TECHNICAL BULLETIN
LTB00998NAS1
01 NOV 2016

'Chirp' Noise From Second Row Seat(s)

Discovery Sport (LC)

E196609

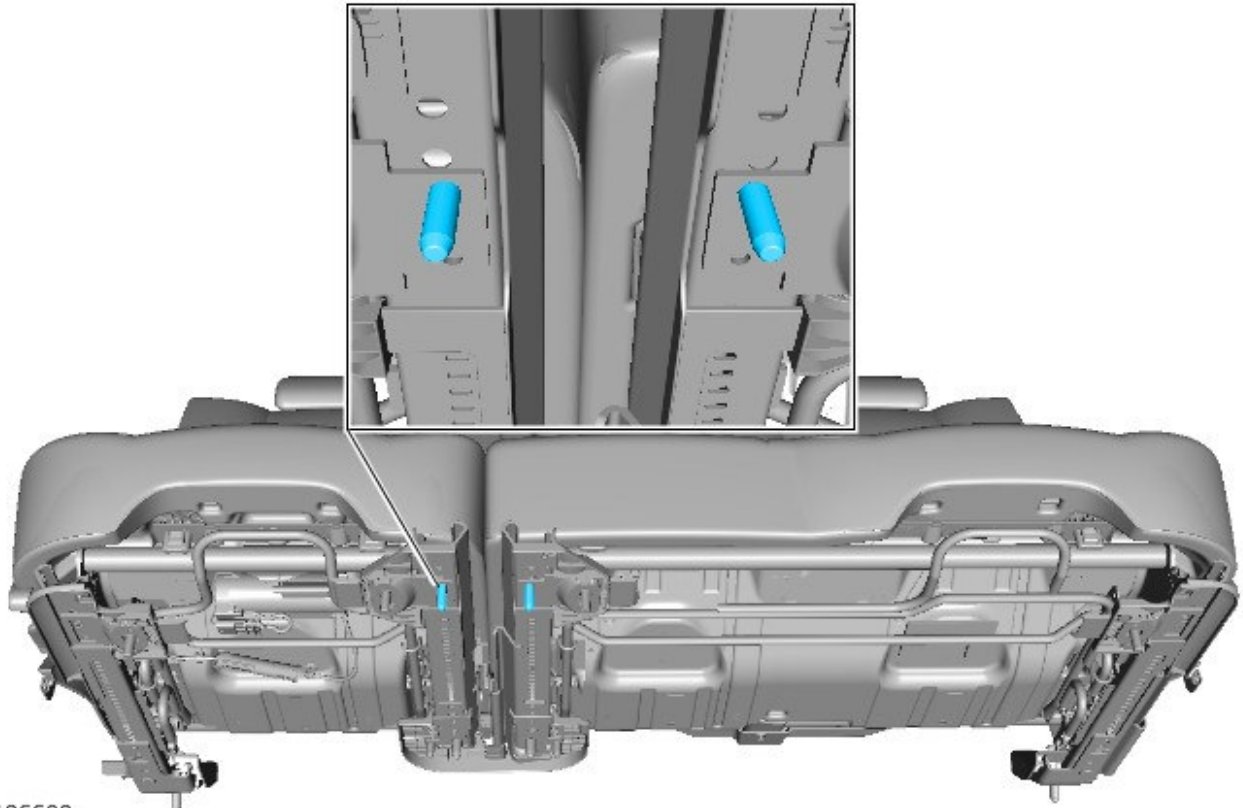
Locate the areas shown.

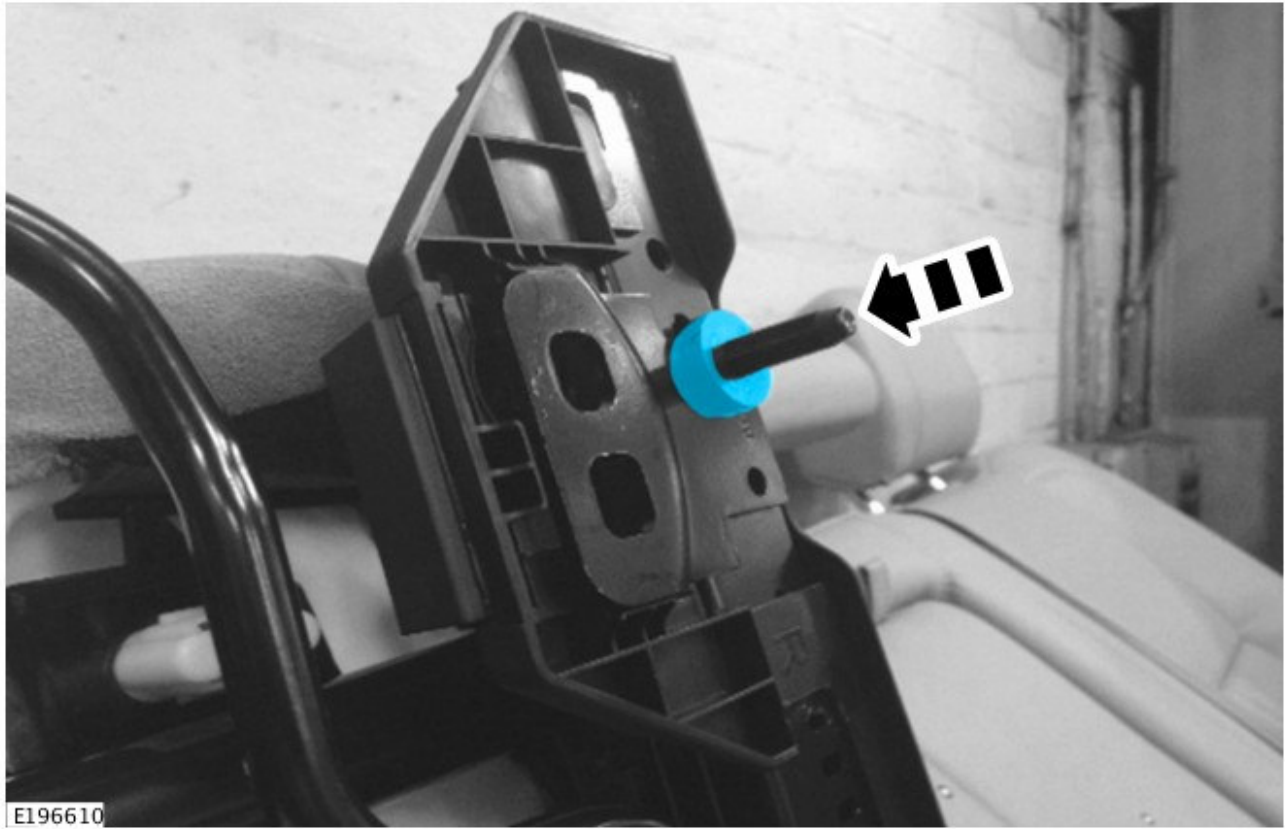
3.  **NOTE: The existing metal washers should still be installed.**

**NOTE: Single seat shown; repeat for double seat as shown in Step 2.**

Install the new nylon spacers.
